Shoreline Alteration/Dredge and Fill Permit Application

SADF-17-07-011

Applicant: Stephen Marriott

September 19, 2017

Looking southwest adjacent wall beyond brick pillar

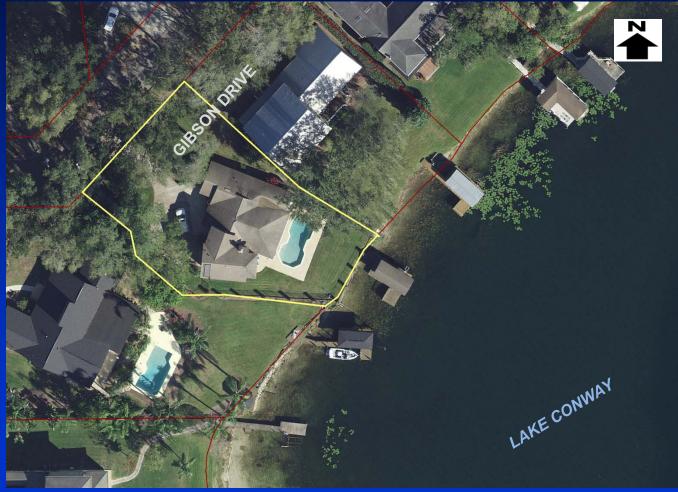
- Review was in accordance with Chapter 33, Article II, Lake Conway Water & Navigation Control District.
- A seawall exists on the property to the south, part of which has been constructed on the applicant's property.
- A concrete drainage structure abuts the property on the north.
- The existing seawall has been in place since at least 1997.
- Significant erosion is occurring behind the wall.

Site Plan

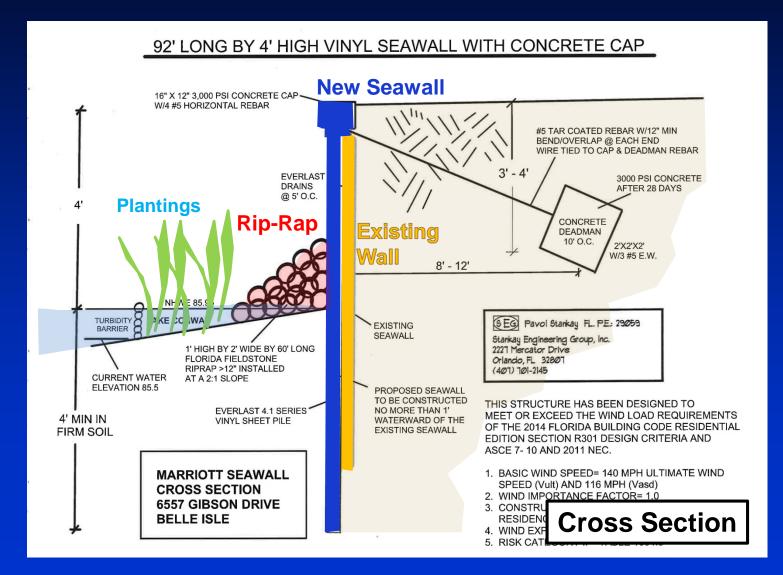
- An engineer has provided signed and sealed drawings.
- The new wall will replace the existing seawall as well as that portion of the adjacent wall that extends onto the property from the south.
- The new seawall is proposed no further waterward than 1 foot of the existing wall.
- Rip-rap and native plantings will be installed waterward of the new seawall.
- Notification of public hearing was sent to property owners within 500 feet of the property.

Approval of the Shoreline Alteration/Dredge and Fill Permit Application, SADF-17-07-011 for Stephen Marriott, subject to the conditions listed in the staff report. District 3.
